ADDENDUM 1 – JOB 4

TO: All prospective bidders on Projects TAU-0008(034), Job No. 4 scheduled for the November 13, 2020 bid opening.

PLAN ADDENDUM SUMMARY AND APPROVAL

| PROJECT INFORMATION | | |
|--------------------------|-----------------|--|
| Project: | TAU-0008(034) | PCN: 22572 |

CONCRETE DRIVEWAY - URBAN

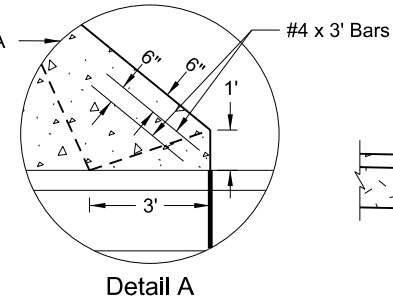
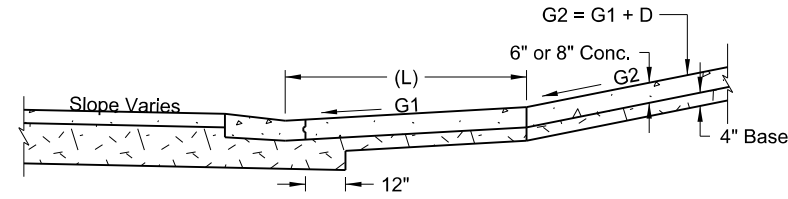
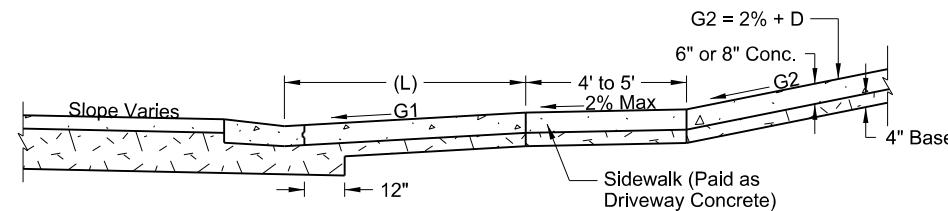
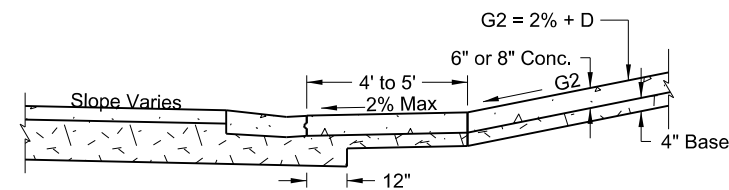
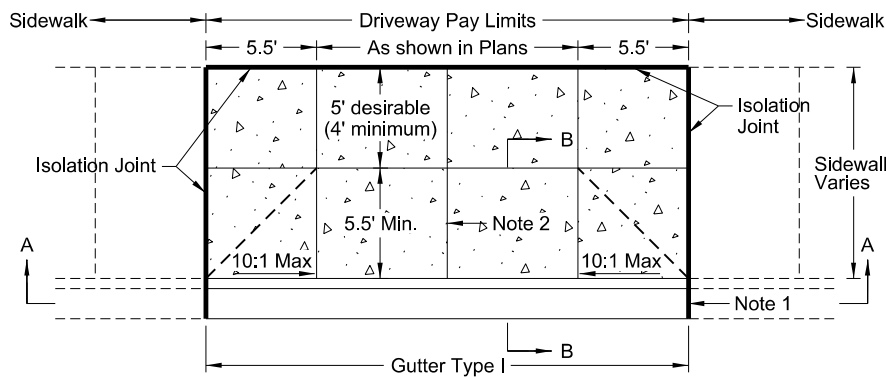
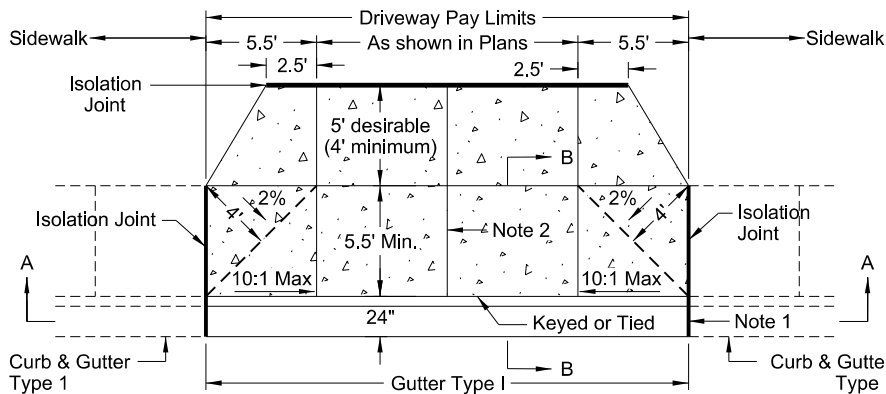
| PLAN SHEET CHANGES | | |
|--------------------|-------|---|
| 2 | 1 | Added Standard Drawing D-750-1 |
